**ZONING AMENDMENT  
& SUBDIVISION STAFF REPORT****Date: December 18, 2014****NAME**

Norden Paper Subdivision

Subdivision to create 3 legal lots of record from 1 metes-and-bounds parcel and 2 legal lots of record, and Zoning to rezone the site from R-1, Single-Family Residential District to I-1 Light-Industry District, to allow access for an existing commercial business.

# SITE PLAN

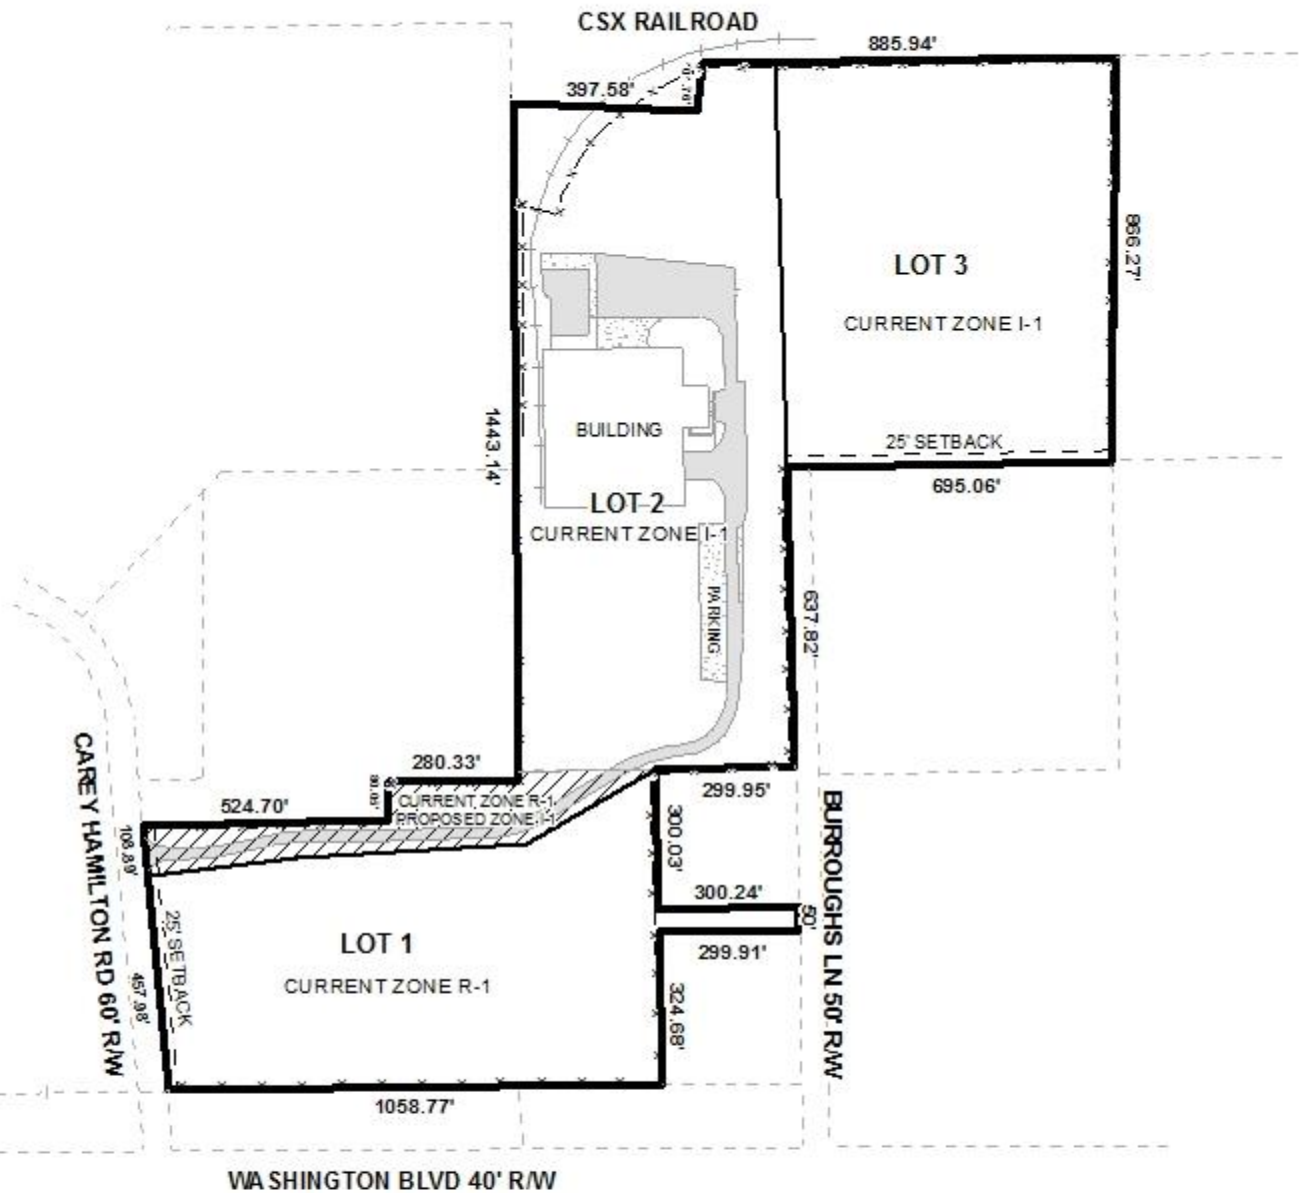
The site currently has one existing curb-cut to Cary Hamilton Road. The applicant is proposing two additional curb-cuts to Burroughs Lane; one for the proposed Lot 1 and the other for the proposed Lot 3. However, Burroughs Lane is considered a residential street; thus staff is

concerned about allowing access to Lot 3, an industrial site, via Burroughs Lane. Therefore, Lot 3 should be denied access to Burroughs Lane and a PUD should be required at the time of development of Lot 3 to allow cross access between lots 2 and 3.

The 25-foot minimum building setback line is depicted on the preliminary plat and site plan except along Burroughs Lane for the proposed Lot 1. The plat and site plan should be revised to depict the 25' minimum building setback line along all proposed lots.

It should be noted, due to the fact the industrially zoned lots abut residential property, the provision of a 25' wide natural vegetative buffer interplanted with evergreen trees and shrubs should be required where the lots abut residentially zoned property. The buffer should be depicted on the Final Plat.

It should be pointed out that the spelling of "Carey" in Cary Hamilton Road is incorrect. The plat and site plan should be revised to depict the correct labeling of Cary Hamilton Road.

- 4) revision of the plat to depict the 25' minimum building setback line along all proposed lots;
- 5) revision of the spelling of Cary Hamilton Road on the Final Plat;

- 6) placement of a note on the Final Plat stating Lot 3 is denied access to Burroughs Lane and is limited to access to Cary Hamilton Road, via Lot 2, which will require a PUD prior to any development on Lot 3;

- 8) placement of a note on the Final Plat and depiction on the plat of a 25' natural vegetative buffer with interplanted evergreen trees and shrubs, required where the site abuts residentially zoned property, to be required at the time of development for Lots 2 and 3;
